# DRAFT RESOLUTION

In the matter of the application of:
**MCDOUGALL AMY E. (PLN230127)**
**RESOLUTION NO. 24--**
Resolution by the Monterey County Planning Commission:

[PLN230127, McDougall Amy E., 10196 Oakwood Circle, Carmel, Carmel Valley Master Plan, (APN: 416-542-011-000)]

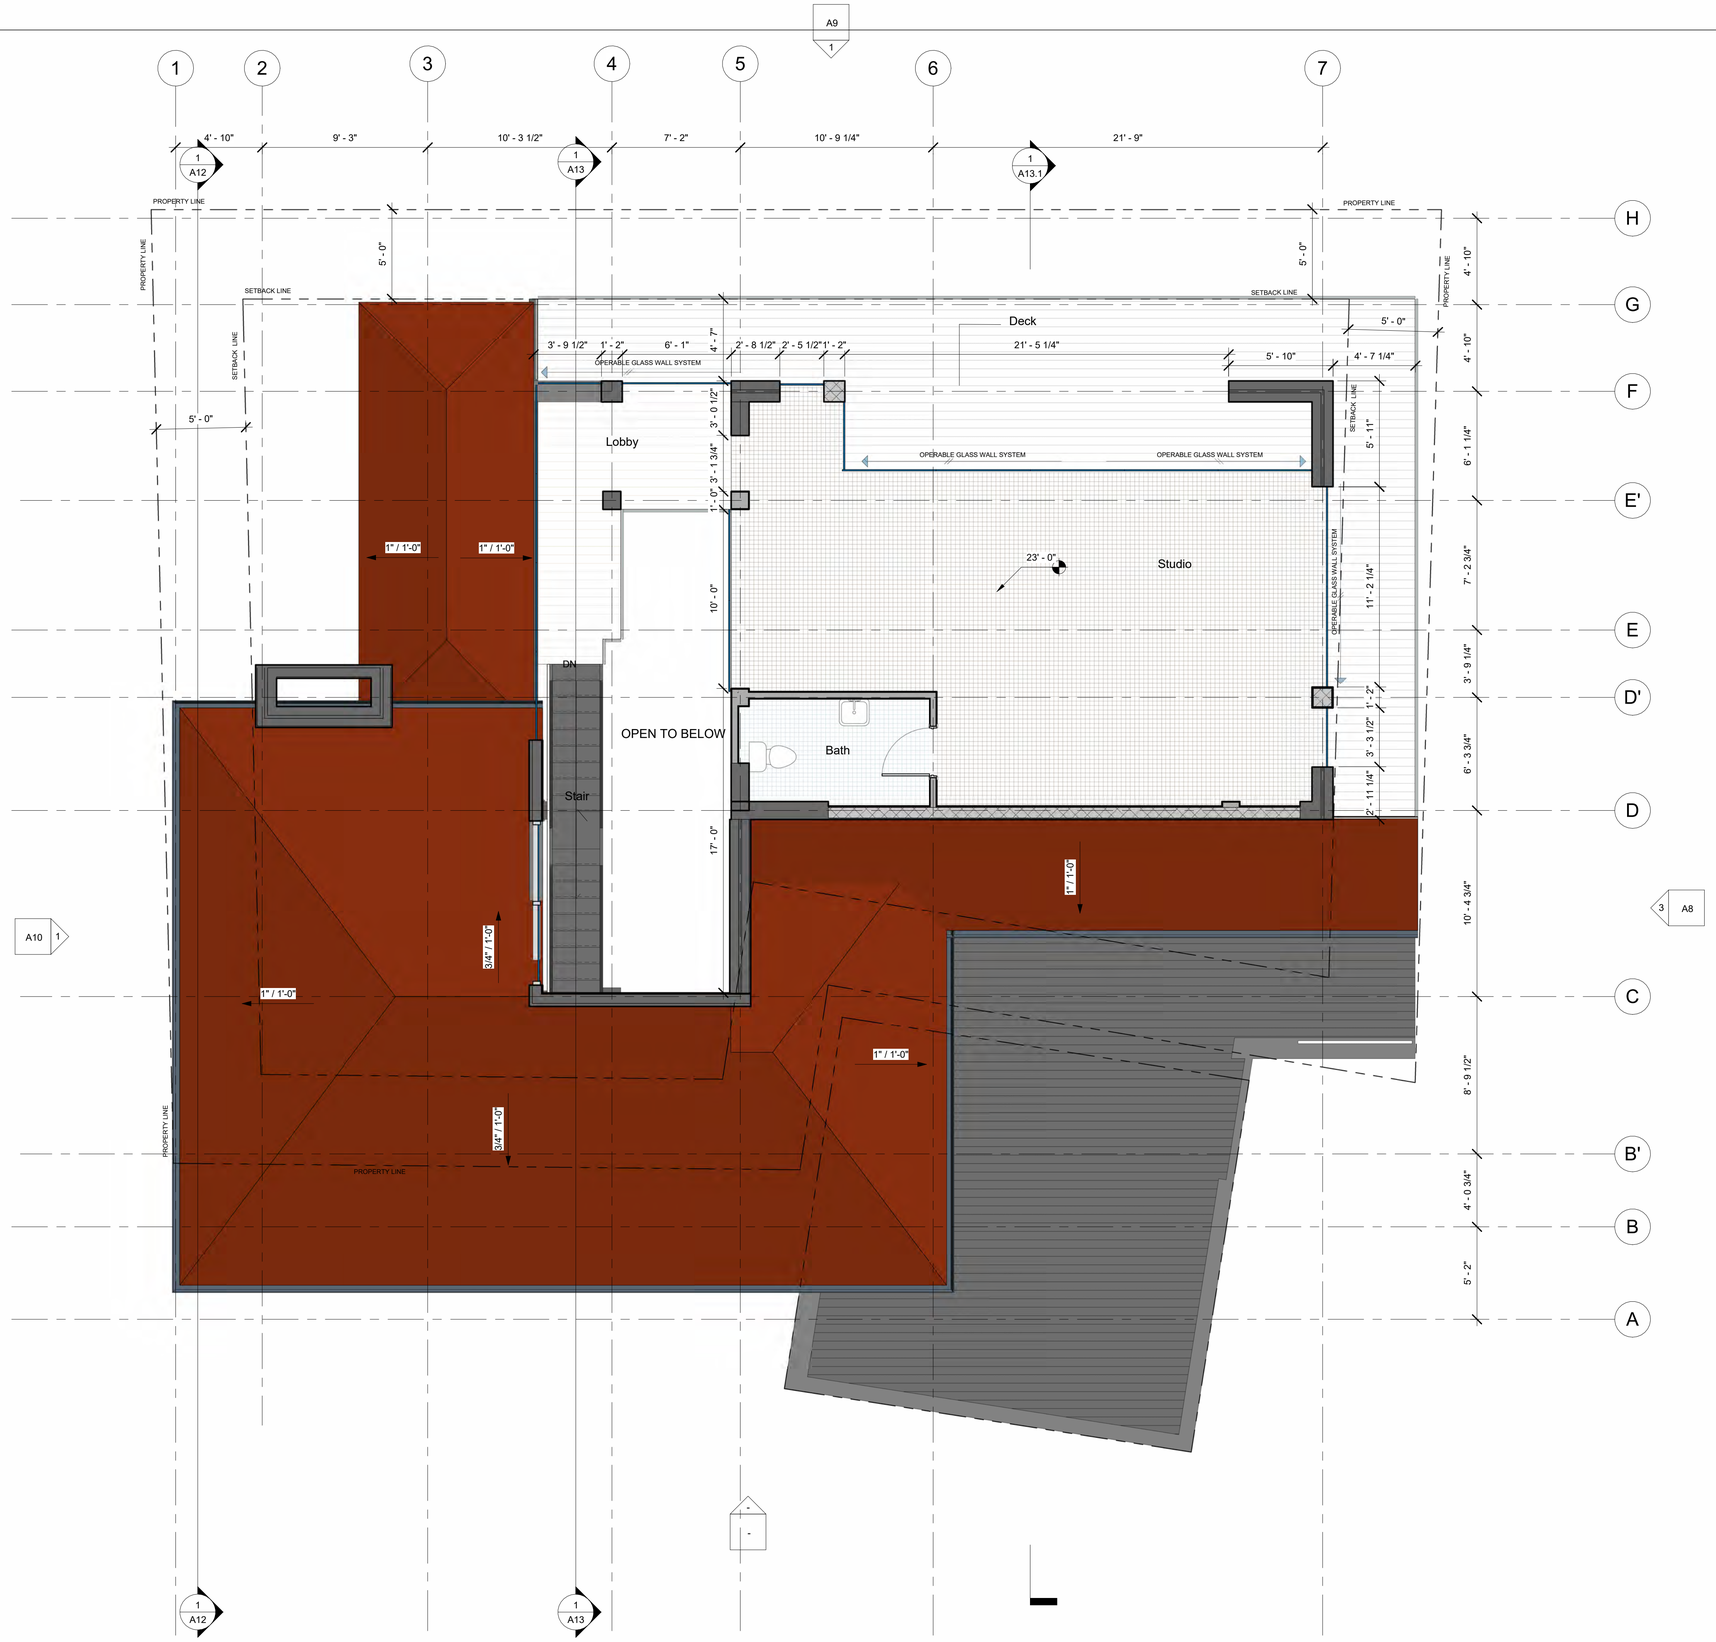
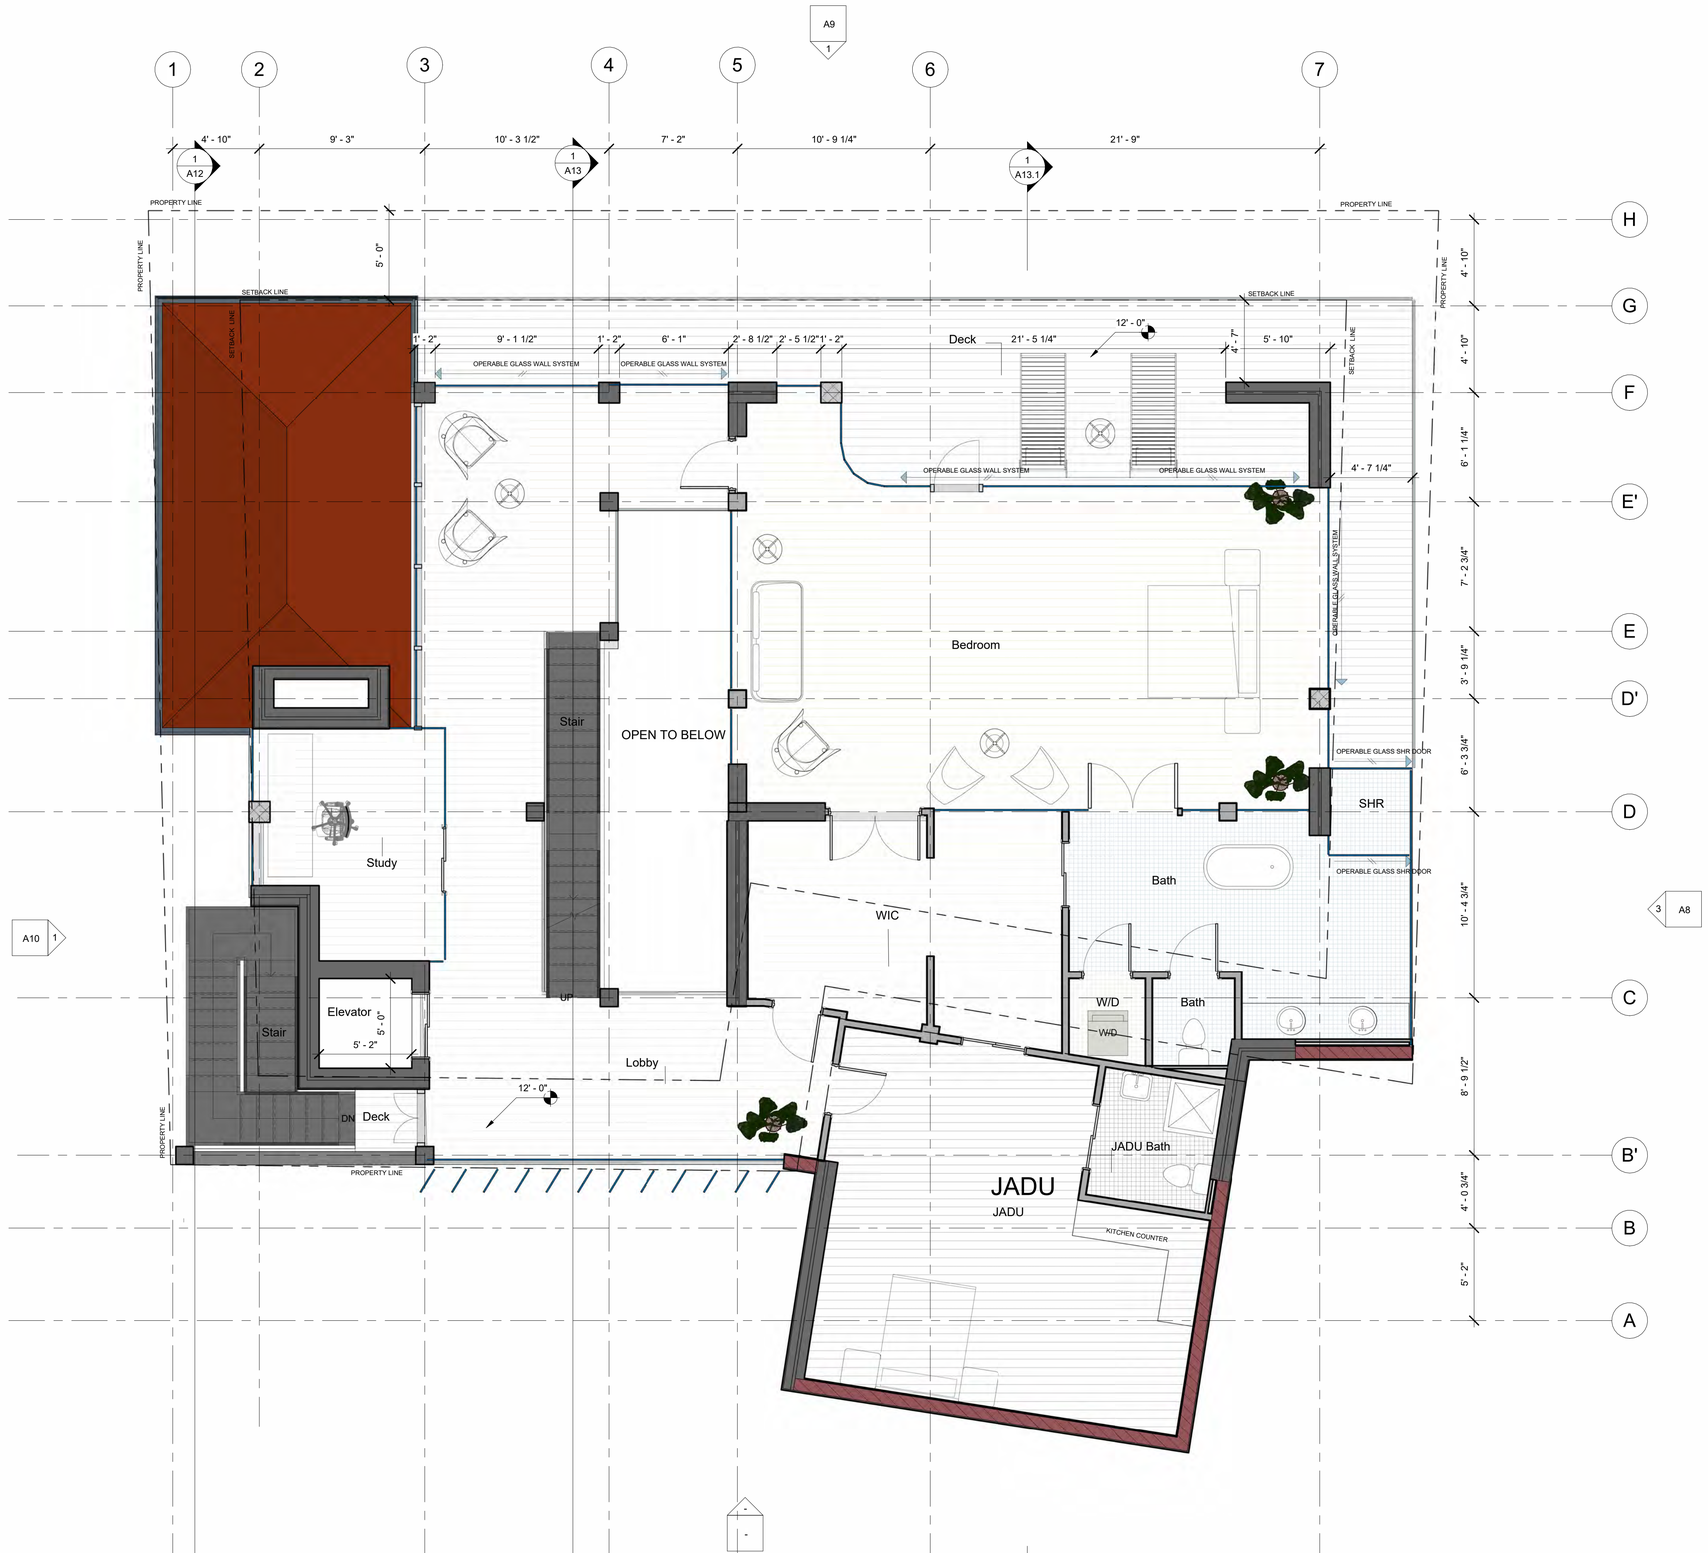
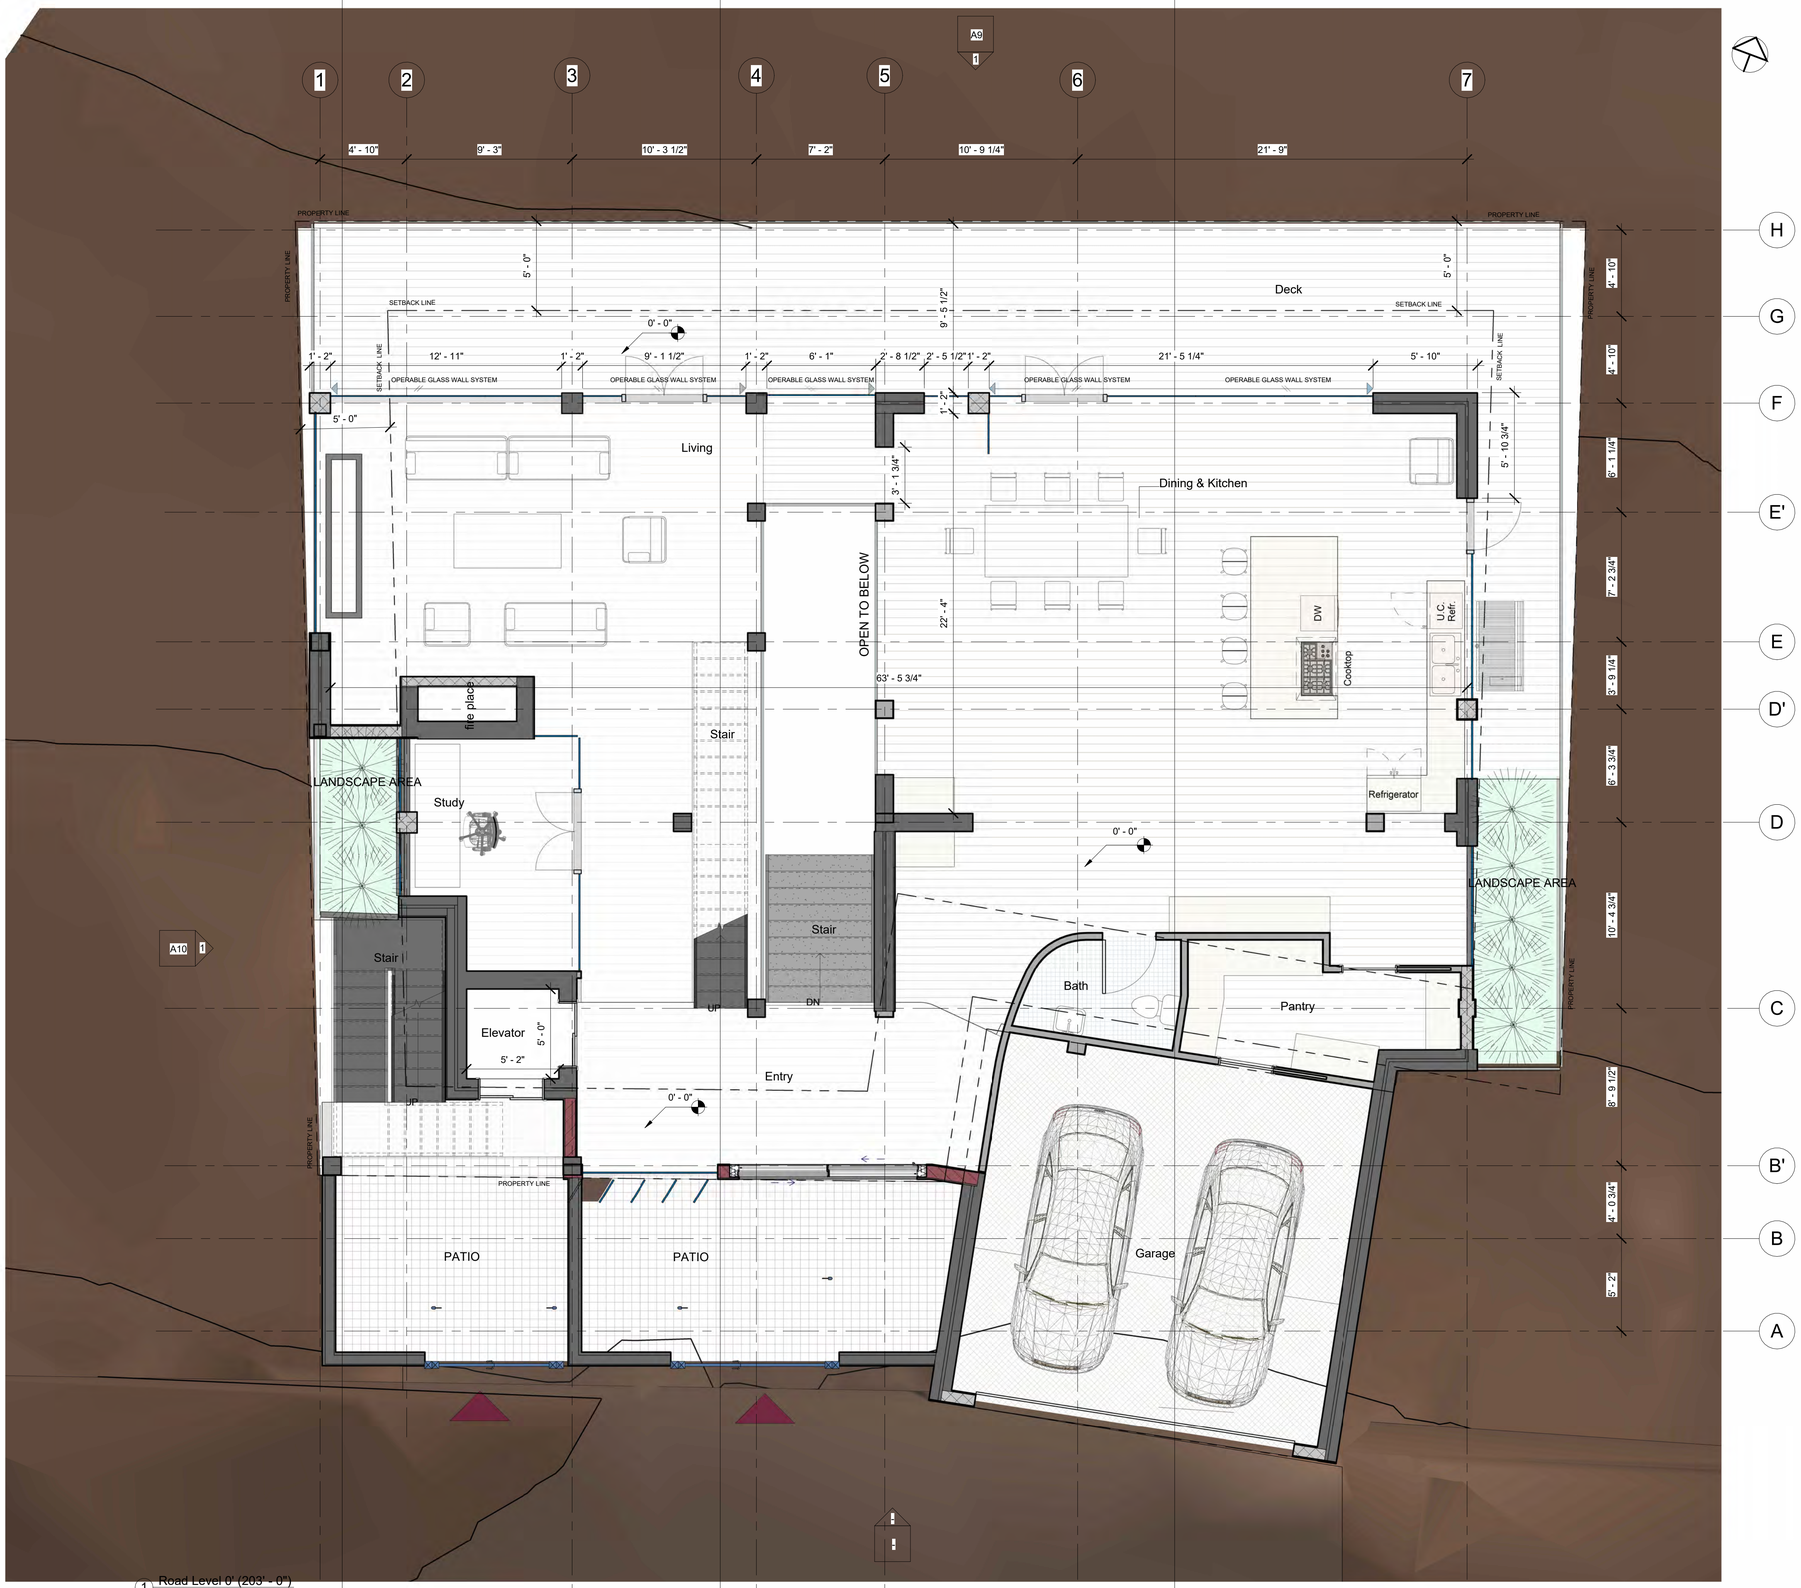
d) Although the proposed ADU has exterior access via a series of staircases, the ADU also has internal circulation with the main residence (see Sheet A5). Additionally, the lower-level basement and well room are only accessible via the ADU. Consequently, the proposed ADU is inconsistent with the requirement that ADUs be independent living quarters that lack internal circulation with the main residence.
